AMENDMENTS TO THE DRAWINGS

SUBMISSION OF FORMAL DRAWINGS

FIG. 1

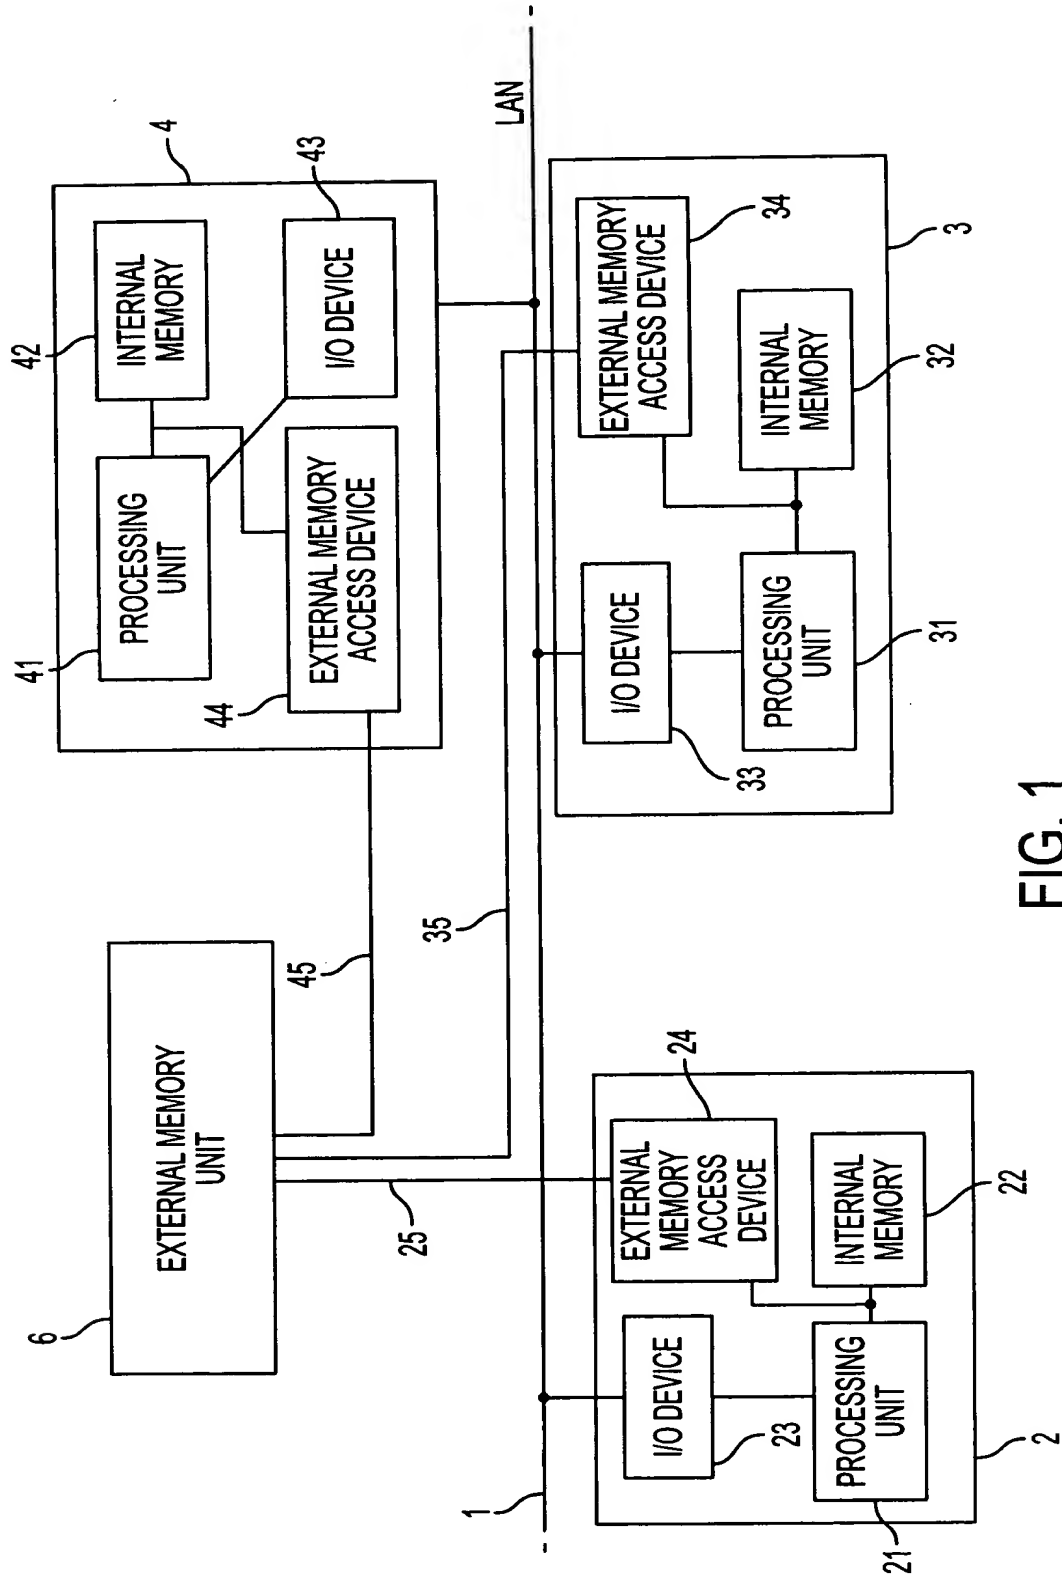
In this response, it is proposed to amend Figs. 1 and 2 in a manner wherein the objections to the drawings set forth in paragraphs #1, 2 and 3 of this Office Action, are overcome. More specifically, the lead line associated with numeral 43 as been changed to lead to the I/O DEVICE included in the machine which has had the numeral 4 and associated lead line added thereto, and numeral 32 associated with the I/O DEVICE included in machine 3, is changed to 33.

FIG. 2

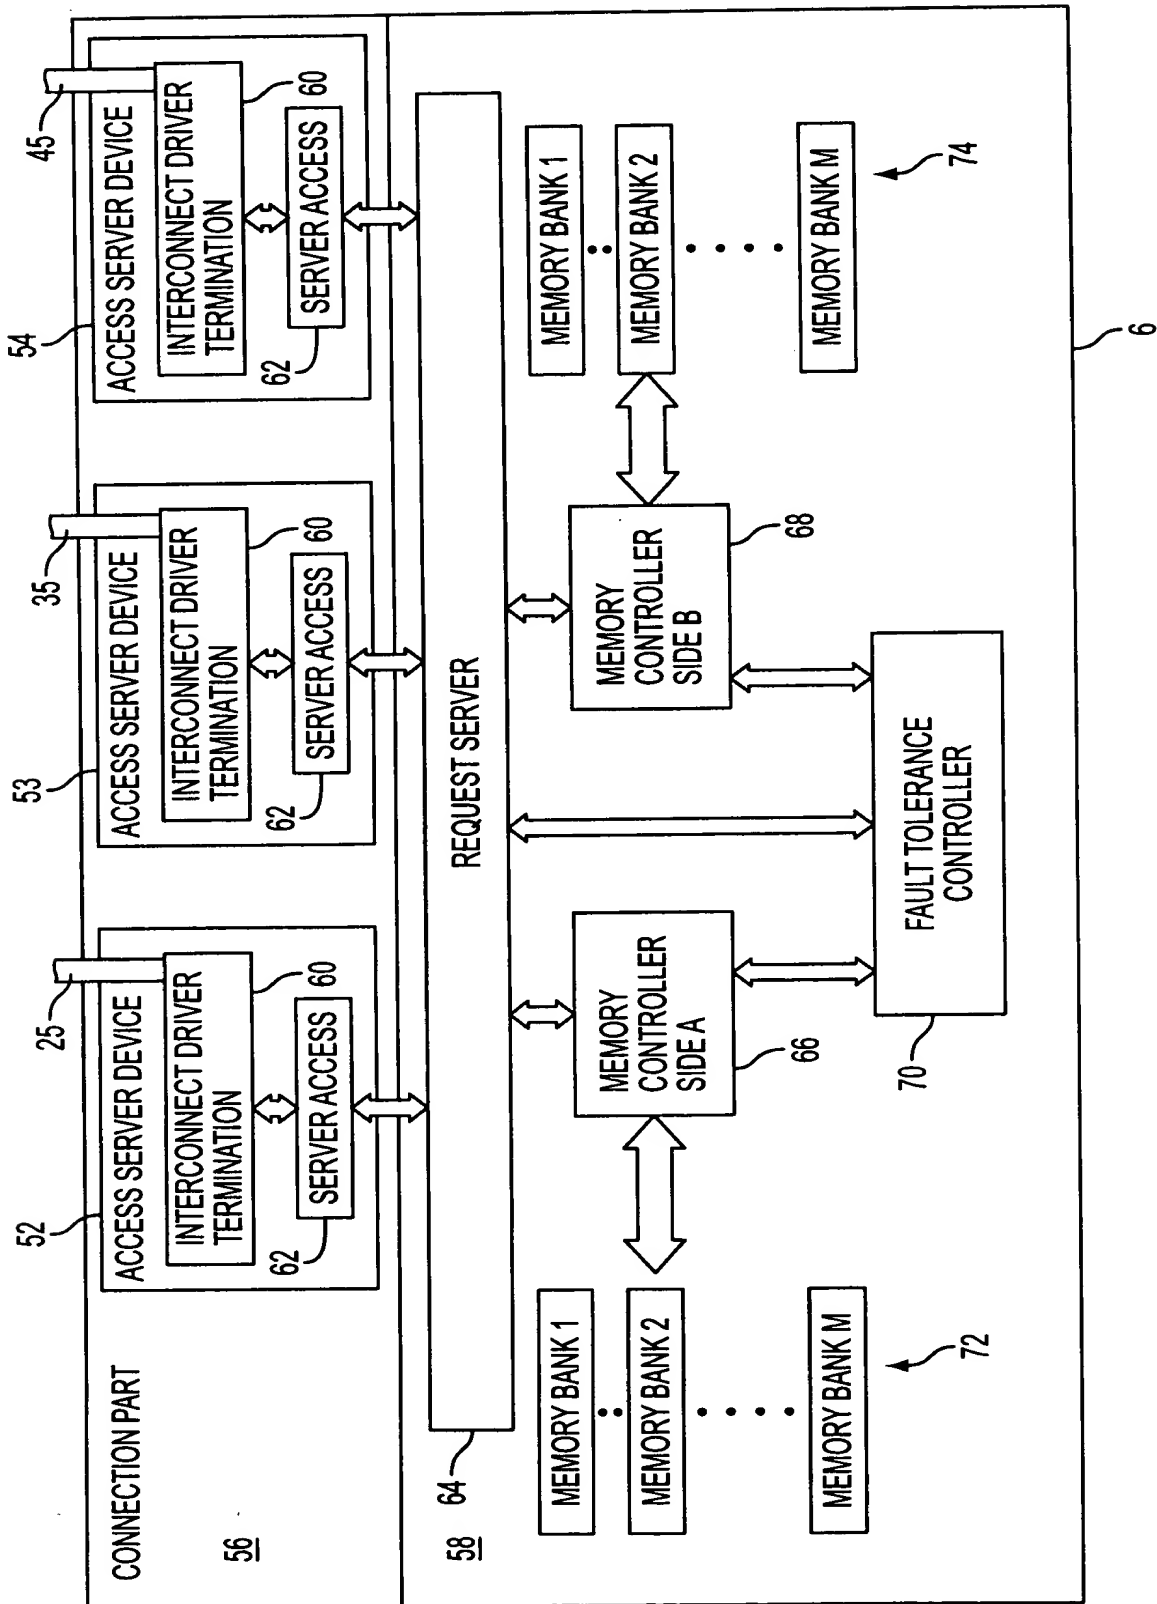
In Fig. 2, numerals 60 and 62 have been respectively added to denote the INTERCONNECTION DRIVER TERMINATION and the SERVER ACCESS blocks in each of the ACCESS SERVER DEVICES 52, 53, 54, and the spelling of SERVER in the "SERVER ACCESS" block (in ACCESS SERVER DEVICE 52), has been corrected.
